**FINAL
BASIN A NECK
GROUNDWATER INTERCEPT AND
TREATMENT SYSTEM
INTERIM RESPONSE ACTION
ALTERNATIVES ASSESSMENT
VERSION 3.2**

SEPTEMBER 1988

RESPONSES TO COMMENTS OF
COLORADO DEPARTMENT OF HEALTH ON
DRAFT FINAL BASIN A NECK GROUNDWATER INTERCEPT
AND TREATMENT SYSTEM INTERIM RESPONSE ACTION
ALTERNATIVES ASSESSMENT

Figure 4-1
Generalized Water Table Contours
Basin A Neck Area

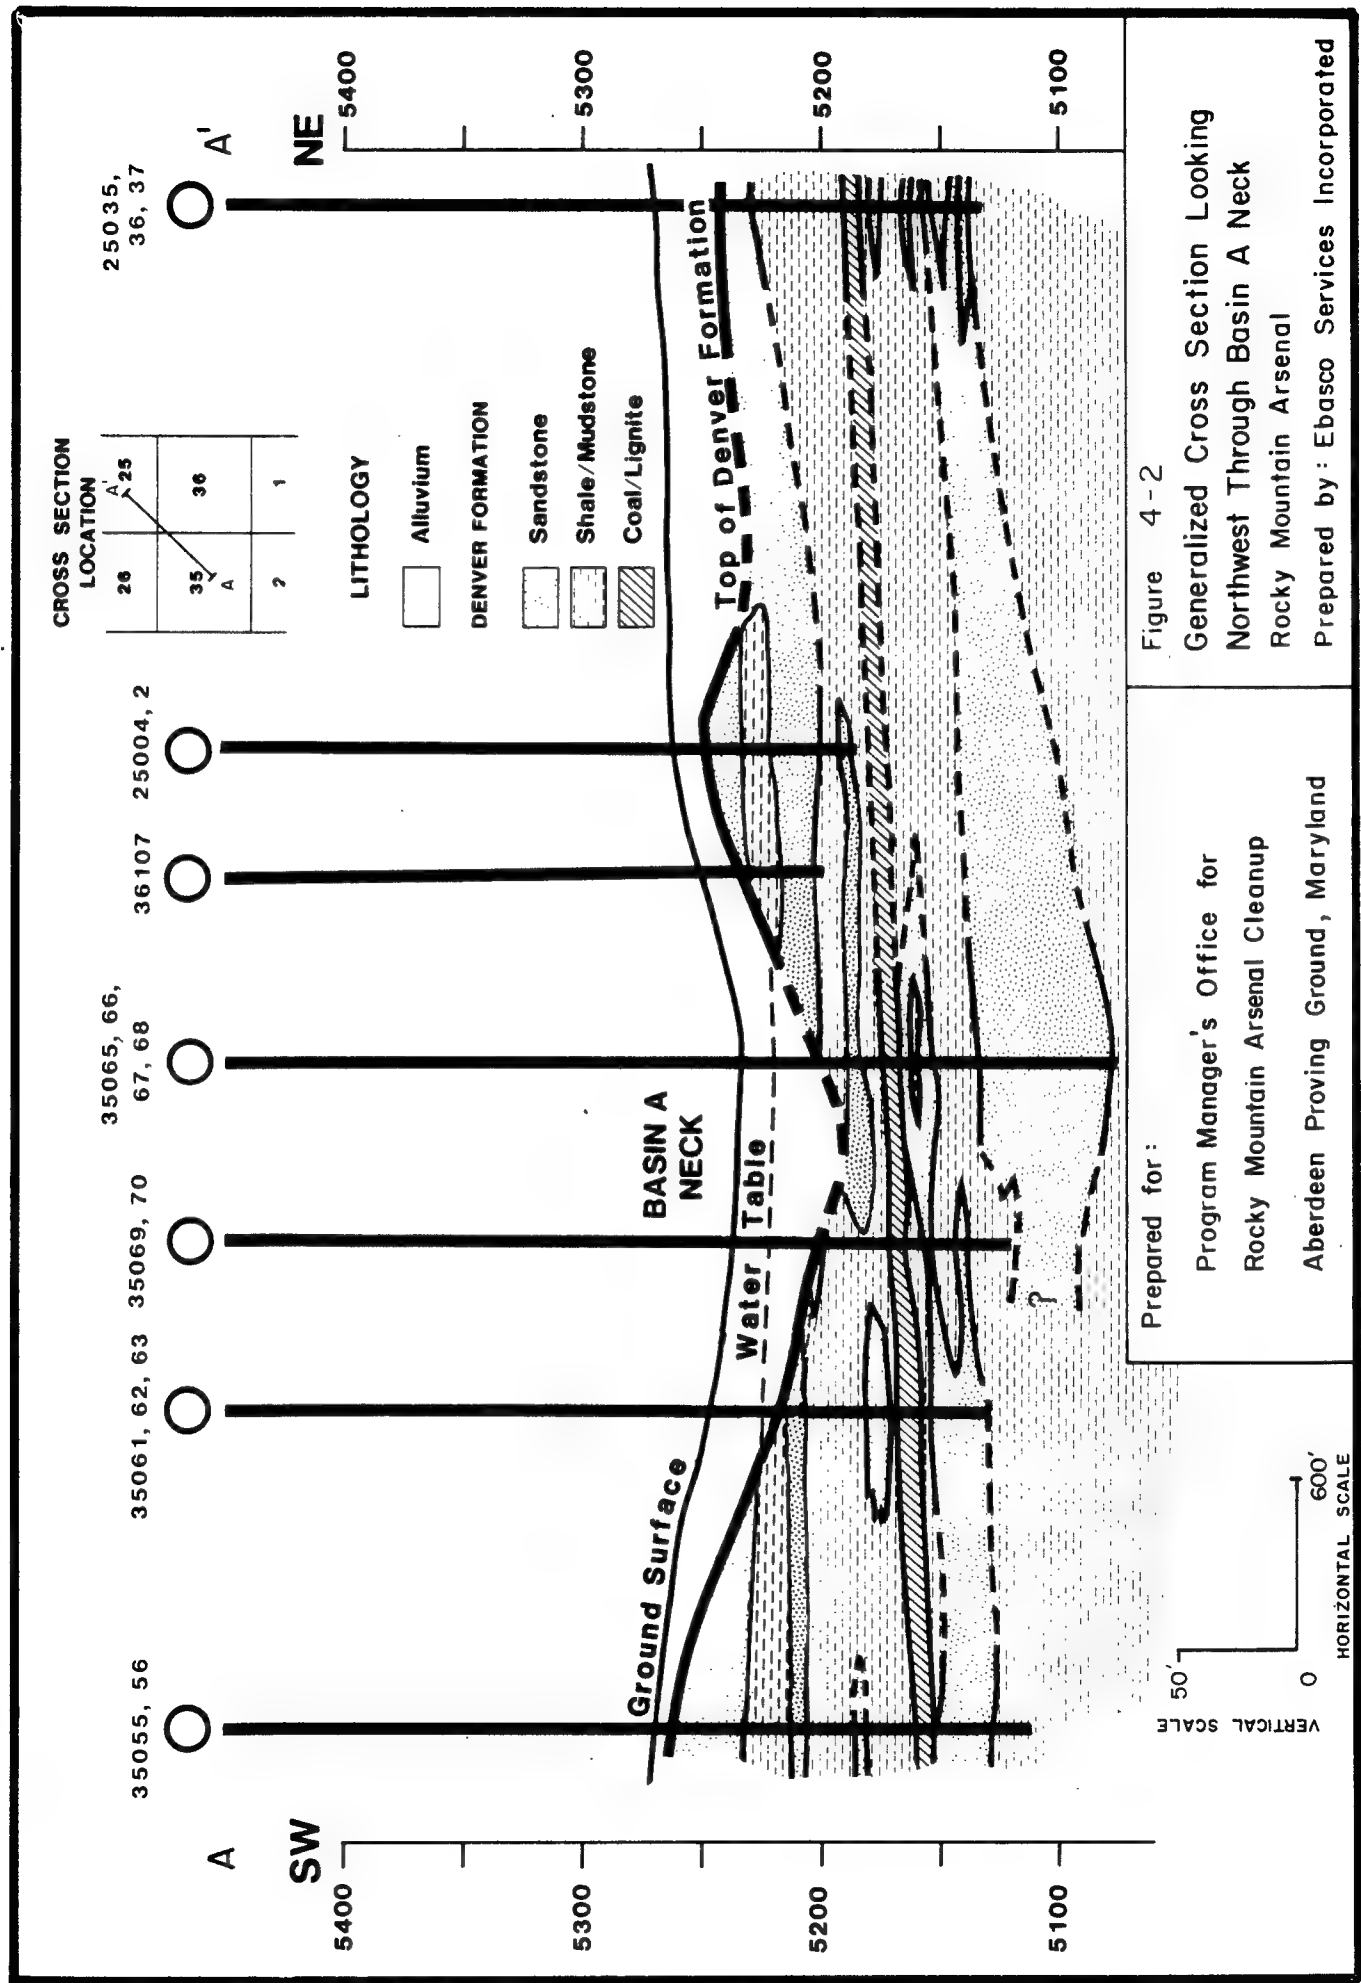
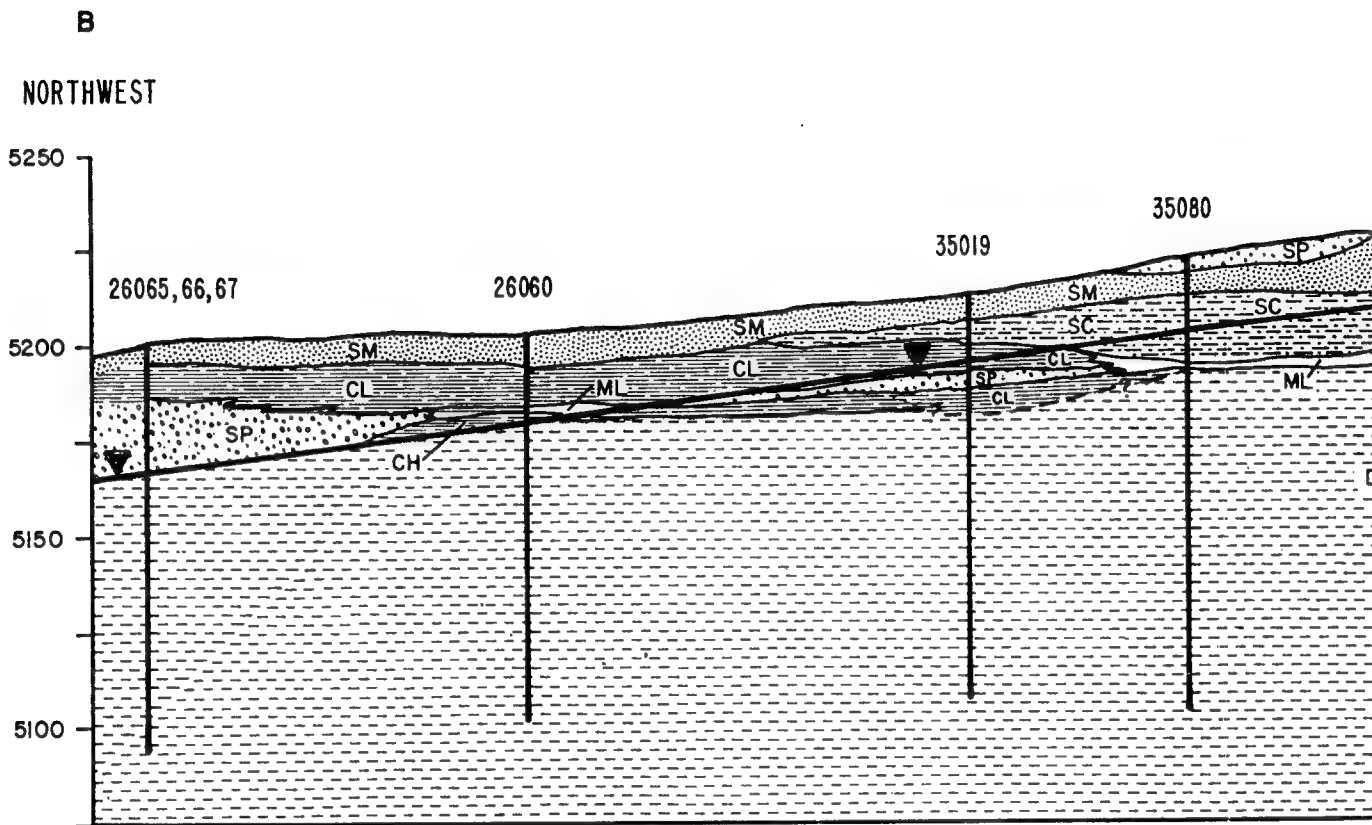
Construction in areas utilized by bald eagles has so far been restricted during the period November 1 to April 1. Bald eagles are known to use portions of the area mapped in Figure 4-1 of the Assessment document. Depending upon the final selection of the response alternative and the contaminated areas to be affected by construction, we recommend you contact either Mr. Pete Gober in Golden (236-2675) or Mr. Mike Lockhart of this office (303-243-2778) for specific guidance required to insure against unnecessary disturbance of wintering bald eagles.

Figure 4-4
Well Location Map

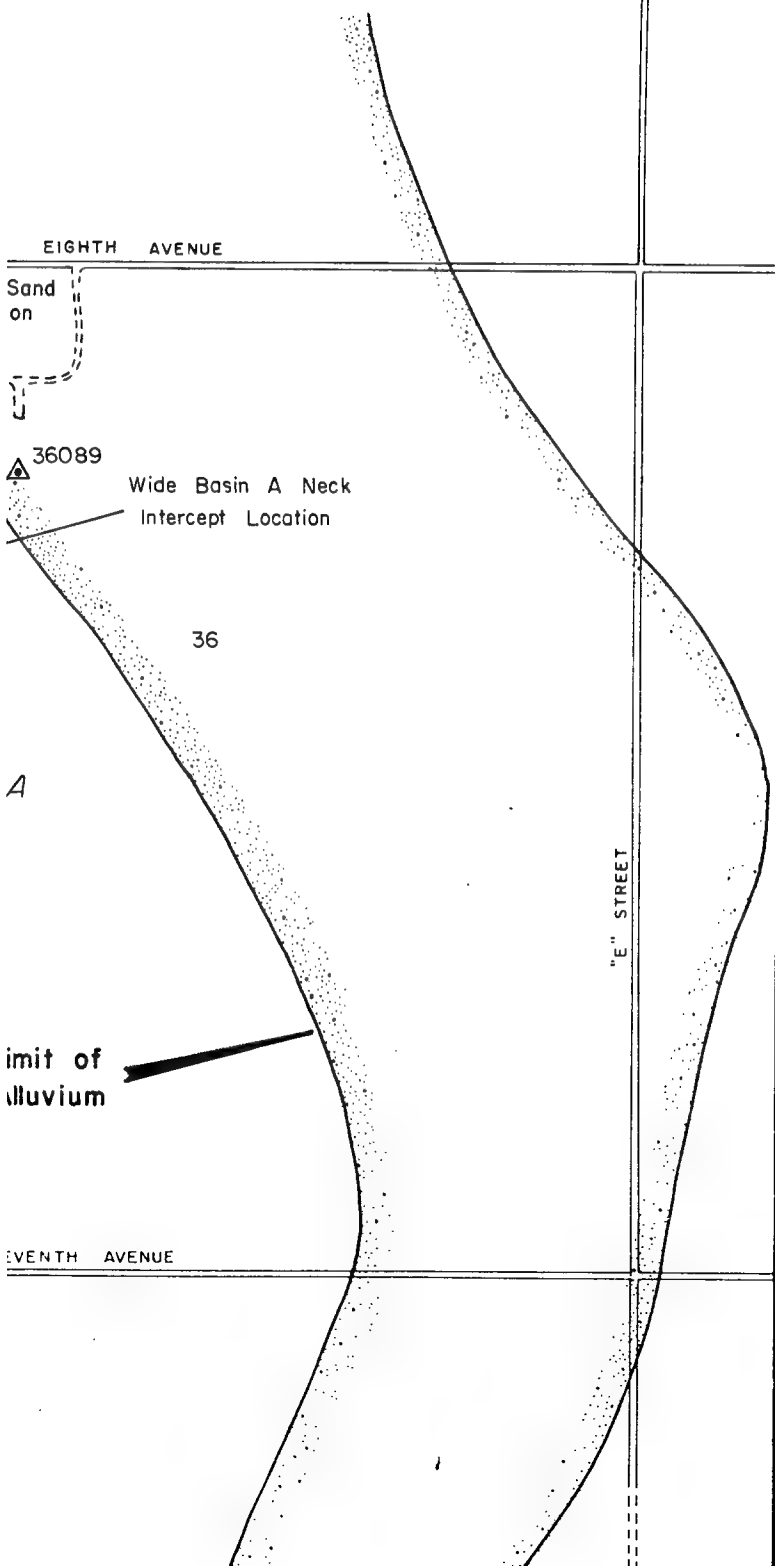
Comment 7: Pg. 42, Table 6.2-1 - Has the remote (Denver formation) component of the proposed narrow Basin A neck system been included in all cost estimates? This report should include separate cost estimates for the two components of the narrow Basin A neck system.

Response: The extent of lateral Denver Formation sand units has not been established. The location shown in Figures 4-1 and 4-4 is conceptual and is not intended to delineate the size of the system, only its approximate location. There is insufficient data at this time to develop costs for the remote Denver Formation component of the intercept system. The costs presented in Table 6.2-1 do not reflect the costs associated with the remote system. The text has been modified to clarify this point.
